TITLE: BARELAS COMMUNITY CENTER
EXISTING FLOOR PLAN / DEMOLITION PLAN

PERIAPPENDIX #2

TITLE: **BARELAS COMMUNITY CENTER**
ENLARGED FLOOR PLAN / DOOR SCHEDULE / DETAILS

Sheet
D1-B

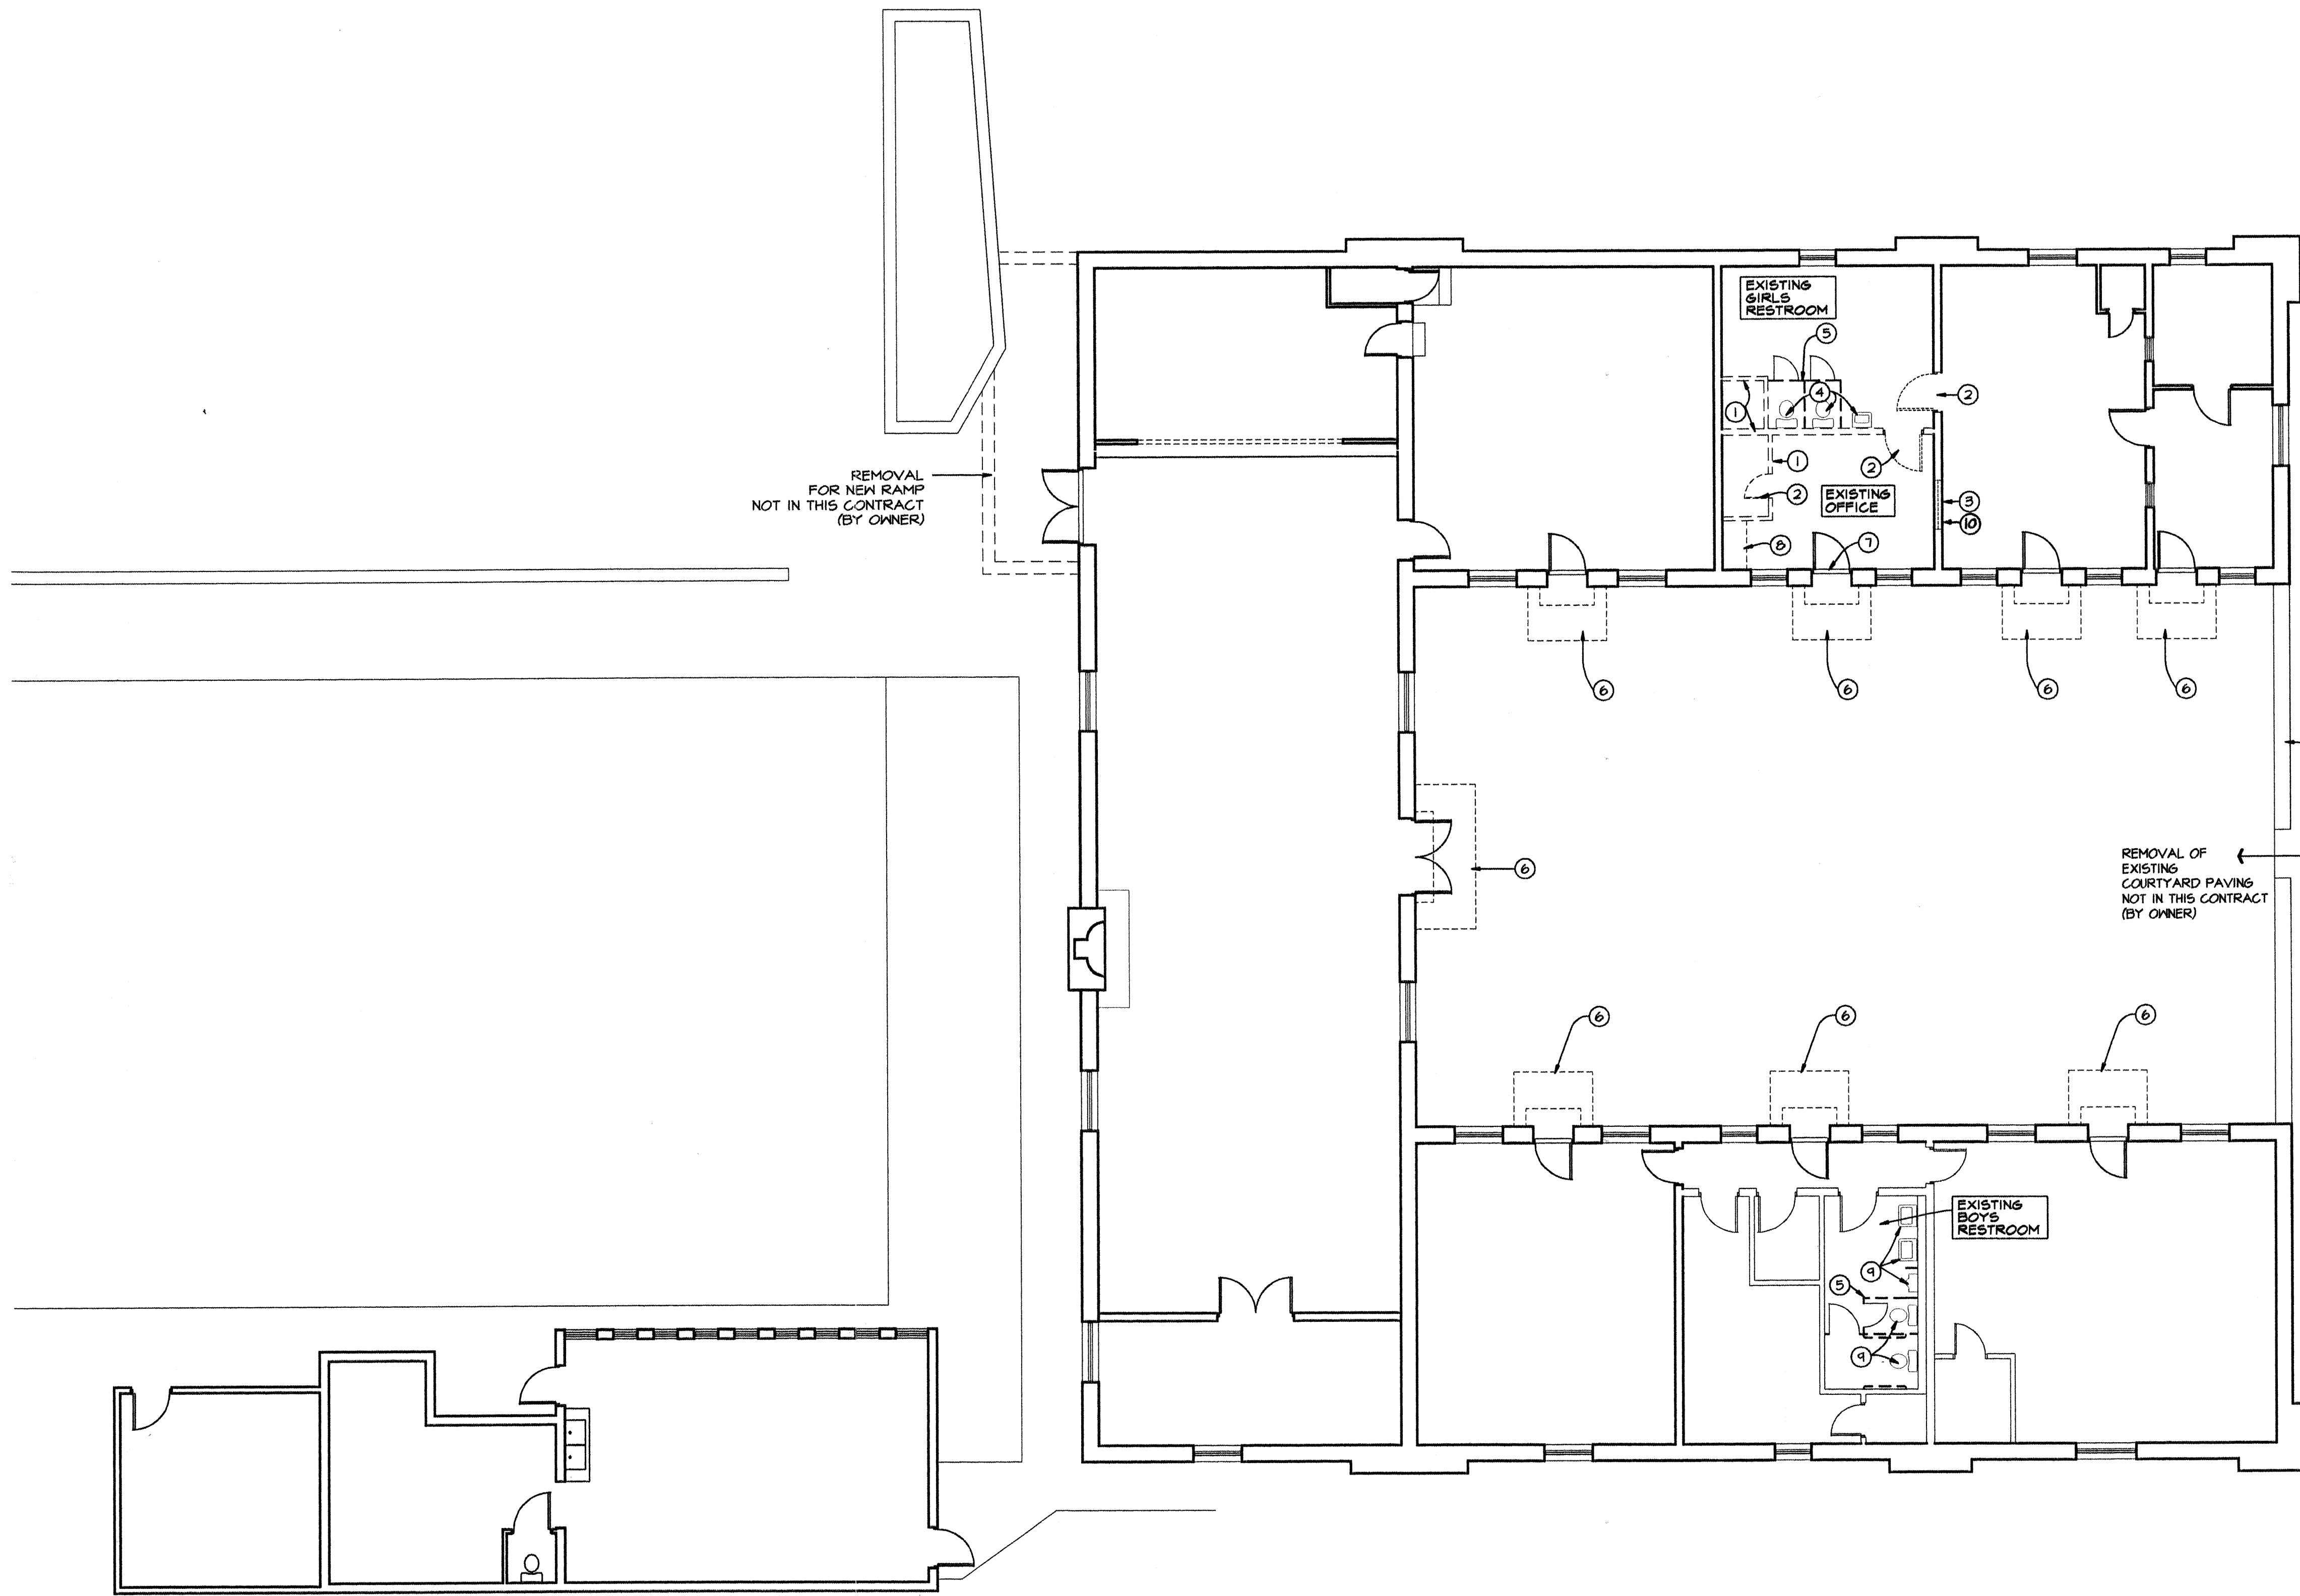
Sheet D1-B: Keyed Note #2, add: Remove door frame as necessary to infill at existing wall. See A2-B.

ENLARGED FLOOR PLAN A 1/4"=1'-0"

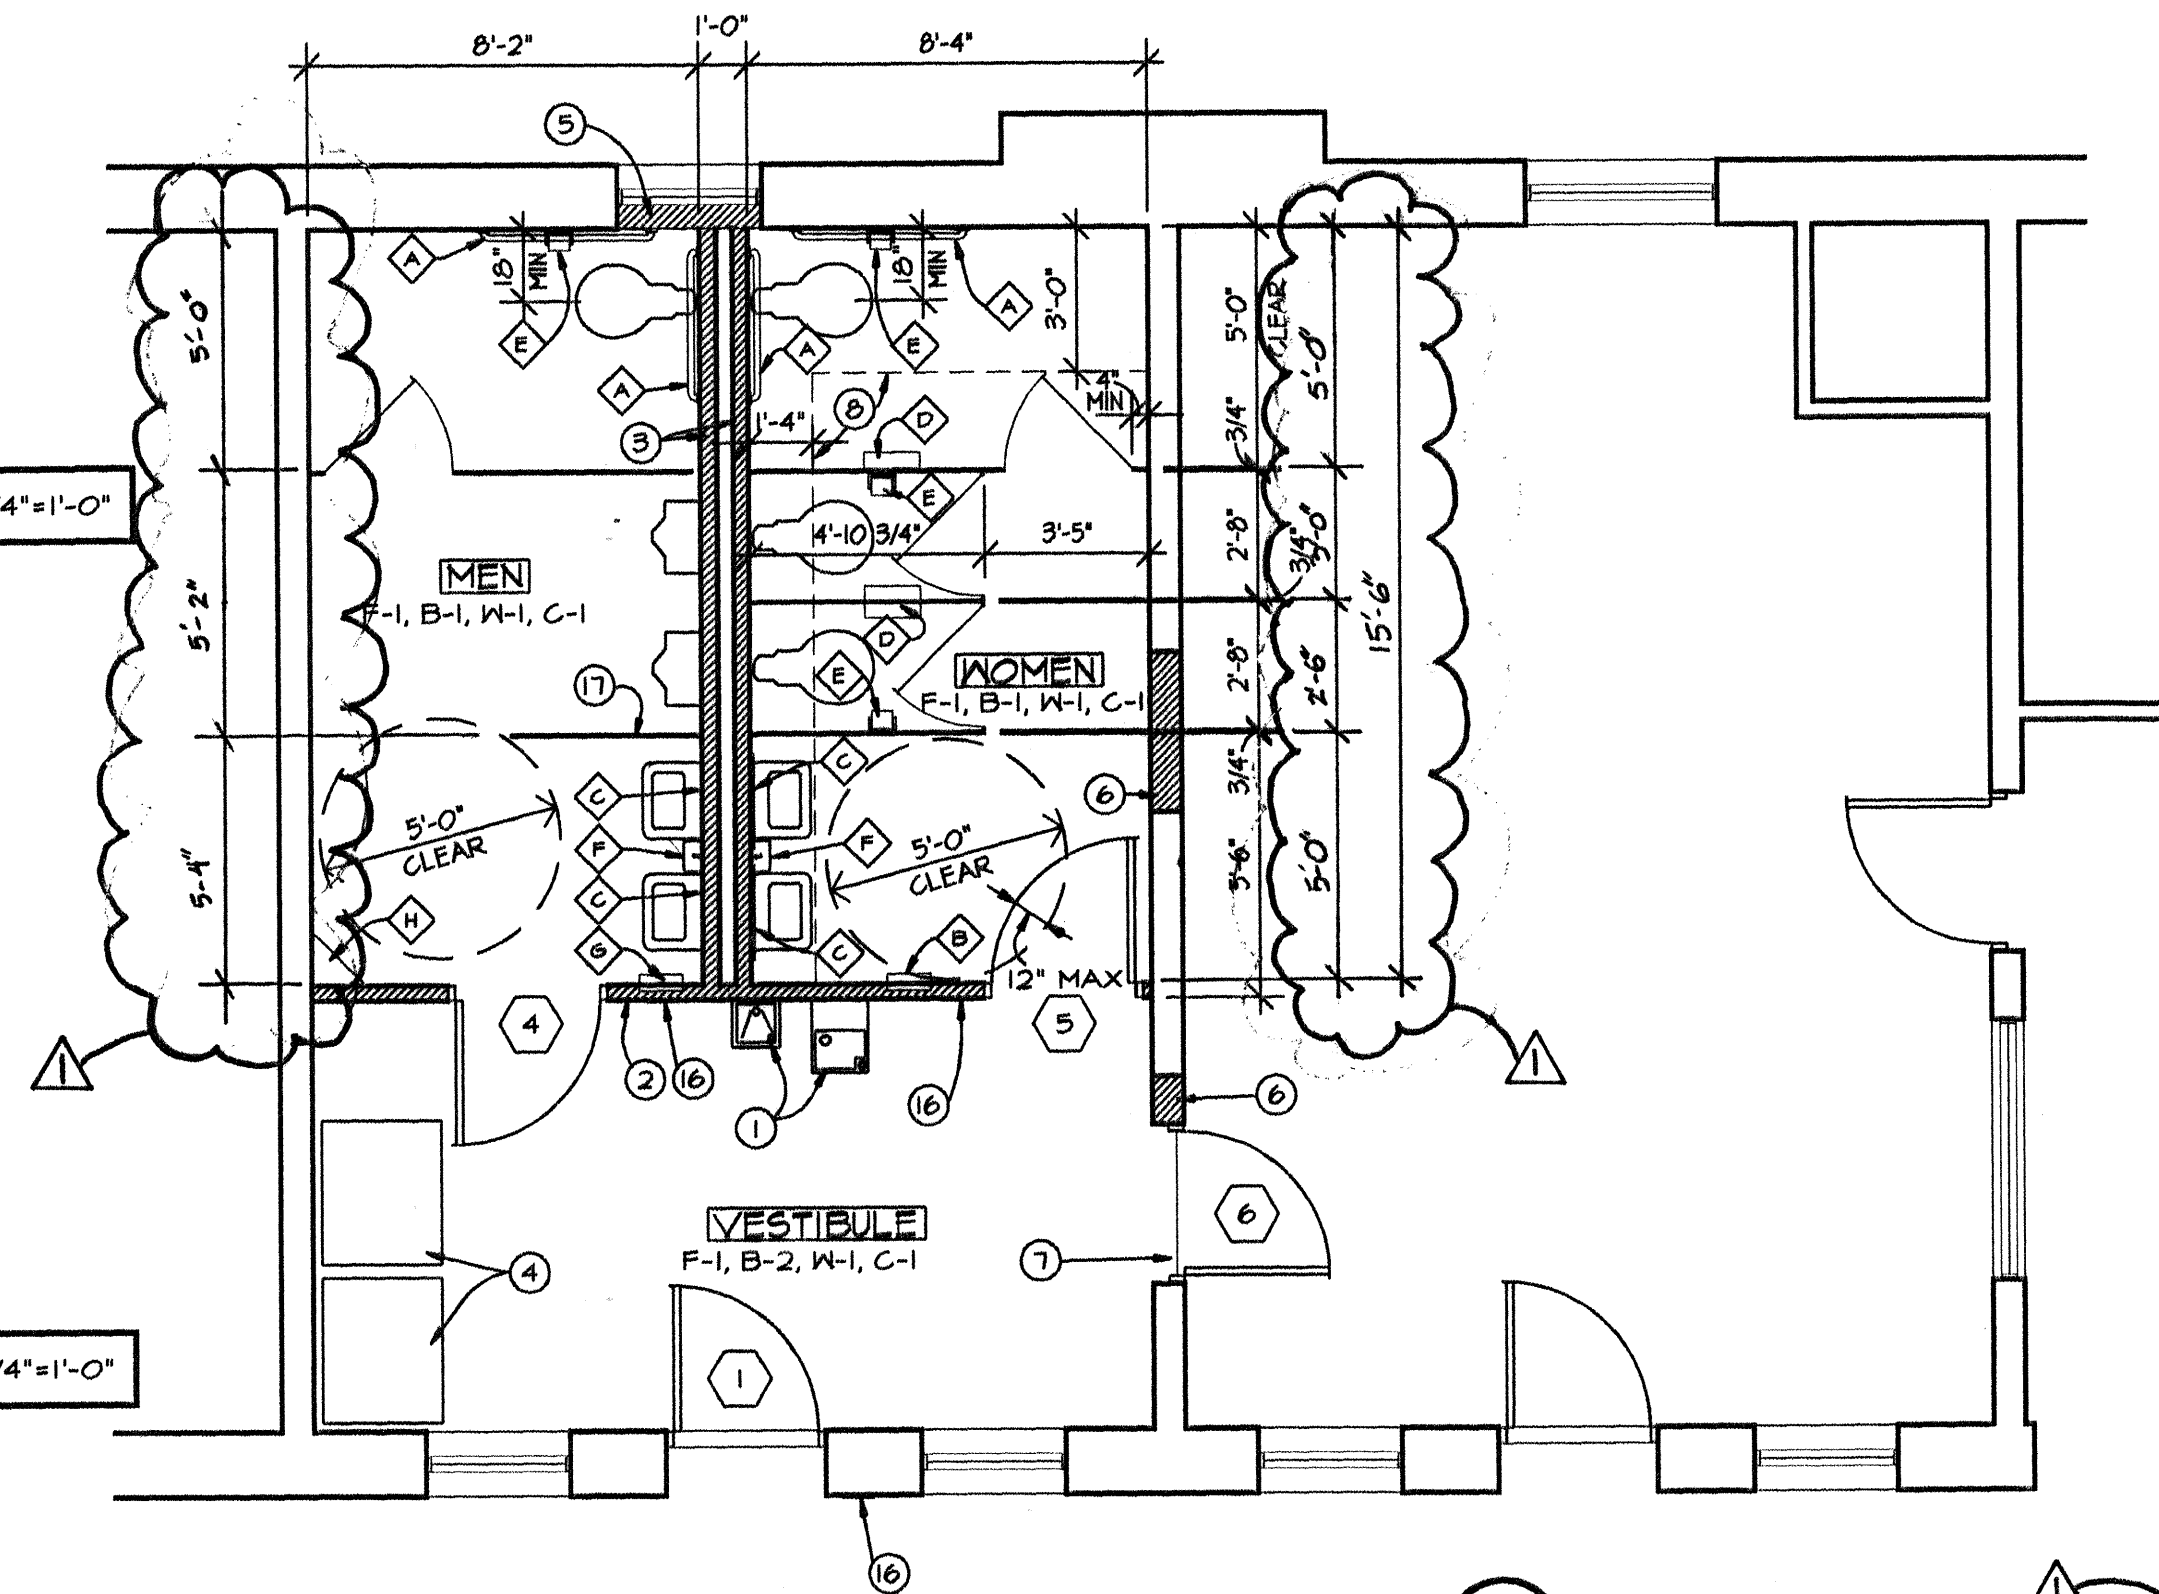
Keyed Note #8, add: in lieu of gypsum plaster, drywall with round corner bead may be used for infill at Contractor's option. Texture and paint to match existing plaster.

Keyed Note #15, add: Expansion anchors may be used at existing locations in lieu of cast anchor shown.

EXHAUST FAN DETAIL

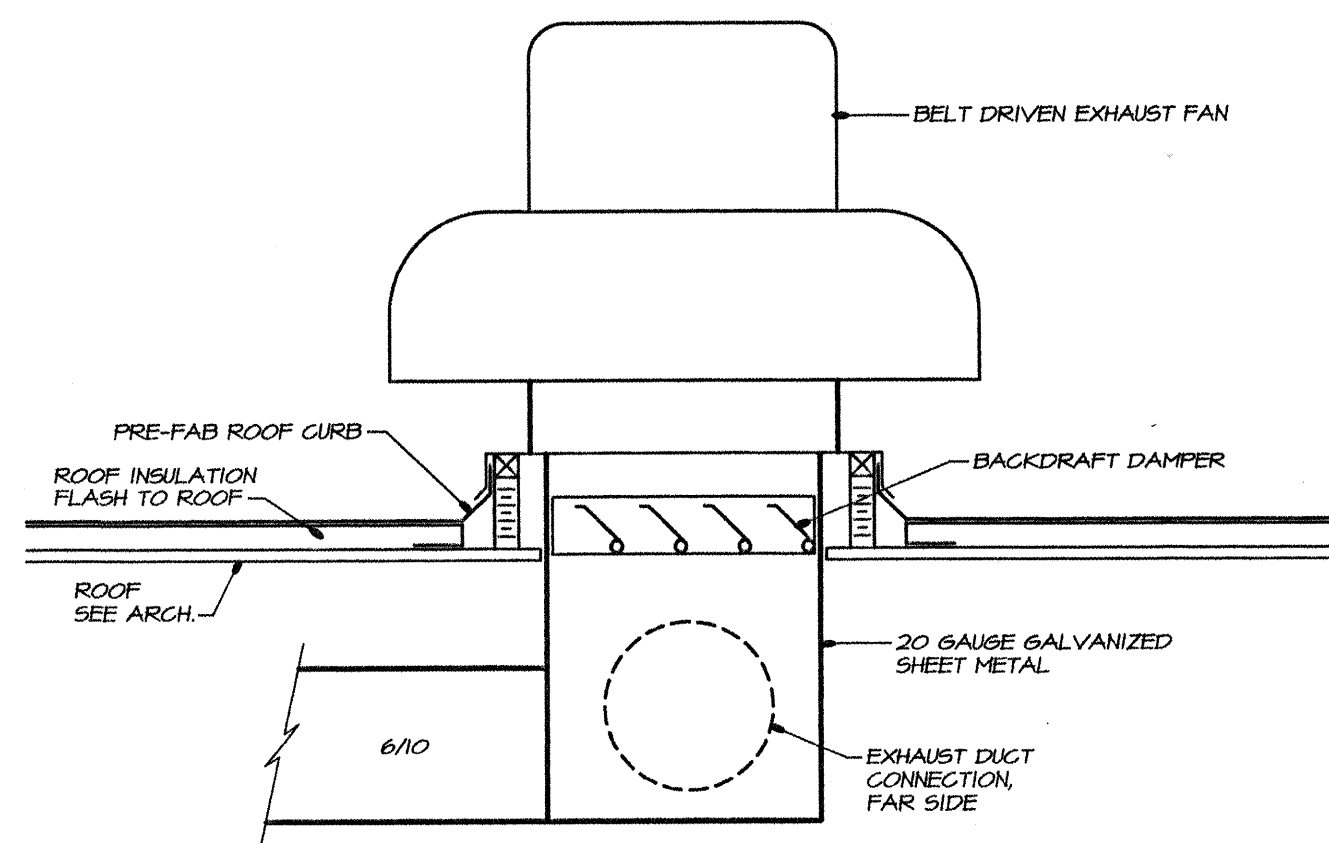
PER ADDENDUM #2
Sheet M2-B: Detail #1: cutback existing built-up roofing and reflash per NRCA and roofing manufacturer's recommendations. See General Notes, Sheet A4-DC, and Specifications.
